1968 Corvette: Service Bulletin: General Information

Bulletin No: 68-T-43

Date: April 24, 1968

Subject: 1968 CORVETTE
GENERAL INFORMATION

Astro Ventilation - Poor Air Flow

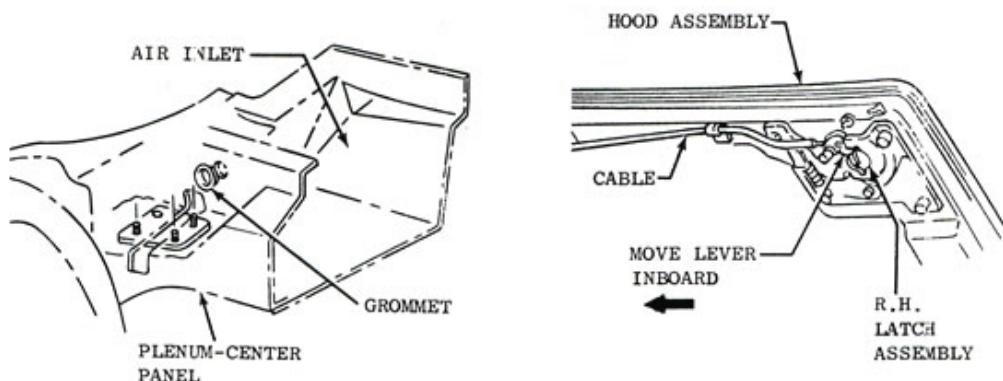
The amount of air flow through the Astro Ventilation System may be restricted if the flapper type valves are improperly cemented to the valve frame. These valves are located under the rear deck and should swing freely as pressure builds up in the passenger compartment.

In instances where the valve action is restricted, separate the rubber flaps from the frame along the bottom and sides. The Astro Vent ducting and cowl kick pad vents should also be checked for leakage as this will reduce air flow at the nozzles.

Rear Bow Lock Remote Control Cable Rattle

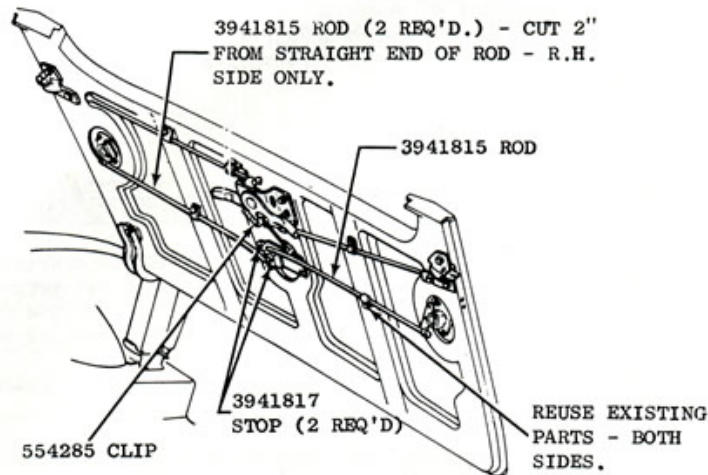
Remote control cables used on early 1968 Corvette Convertible models could rattle against the rear compartment lid. Production replaced these cables with rods on 1/2/68.

Complaint vehicles may be updated by installing the rear bow lock remote control rods as indicated on the sketch below.

Headlamp Door - Inoperative

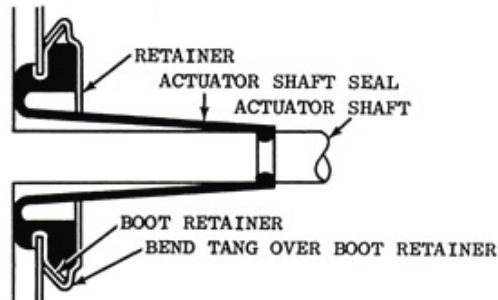
Headlamp doors which become inoperative due to sticking actuator shaft seals, should be corrected by replacing the inner shaft seal. This seal, in some cases, will stick to the actuator shaft causing the seal to pull out of the actuator. The headlamps may be operated manually as outlined in the 1968 Corvette Owners Manual when this occurs. The new style actuator seals went into production effective with Serial No. S410514. The actuator seals may be replaced as follows:

1. Remove actuator assembly per Section 12, Chassis Service Manual
 2. Remove the outer boot from the actuator
 3. Remove the inner seal and wipe the seal flange and actuator shaft dry

4. Installation and lubrication of actuator shaft seal
 - a) Install seal using protective cover over shaft threads (protection is needed to avoid cutting of internal seal bead by threads)

- b) Make certain seal grommet is properly seated in the actuator cover and interior bead at small diameter of seal fits in the groove on the shaft (See sketch)

- c) Apply a liberal film of silicone lubricant over entire exterior surface of actuator shaft seal, excluding grommet
 5. Install the retainer by bending the three (3) tabs over edge of boot retainer. (See sketch)

- IMPORTANT:** Do not distort boot retainer when bending over the tabs. If distorted, leakage can occur
6. Install the outer boot and reinstall the actuator assembly as described in Section 12 of the Chassis Service Manual
